Mitsubishi Motors North America, Inc.
SERVICE CAMPAIGN BULLETIN

**ENGINE CONTROL UNIT (ECU) REFLASH
- SERVICE CAMPAIGN**

No: SC-26-003

2026 Outlander with 4B40 Gen 2 Engine

REPROGRAMMING PROCEDURE

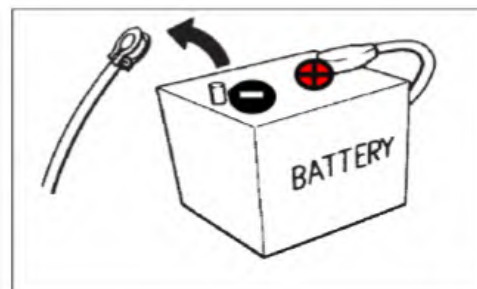
This software update addresses fault codes P0128-00, P2096-00 and P050A. Ensure the **MUT3-SE software version is #994 or higher**, and perform the procedure below:

* If the software part number matches SW Part No./Ver. highlighted by **yellow** above, perform a battery reset **after** ECU reprogramming. Otherwise, DTC P2096 may recur due to retained learned values.

Model	Data No.	New HW Part No.	New SW Part No./Ver.	Target HW Part No.	Target SW Part No./Ver.		Remarks
					After P0128 reprogramming	Before P0128 reprogramming	
Outlander	23761W41.9PN	-	23761W419P	23703W013P	23761W361P	23761W277P	2WD CRUISE CONTROL
	23761W42.0PN	-	23761W420P		23761W362P	23761W278P	2WD ADAPTIVE CRUISE CONTROL
	23761W42.1PN	-	23761W421P		23761W363P	23761W279P	2WD MI-PILOT Assist
	23761W42.2PN	-	23761W422P		23761W364P	23761W280P	4WD CRUISE CONTROL
	23761W42.3PN	-	23761W423P		23761W365P	23761W281P	4WD ADAPTIVE CRUISE CONTROL
	23761W42.4PN	-	23761W424P		23761W366P	23761W282P	4WD MI-PILOT Assist
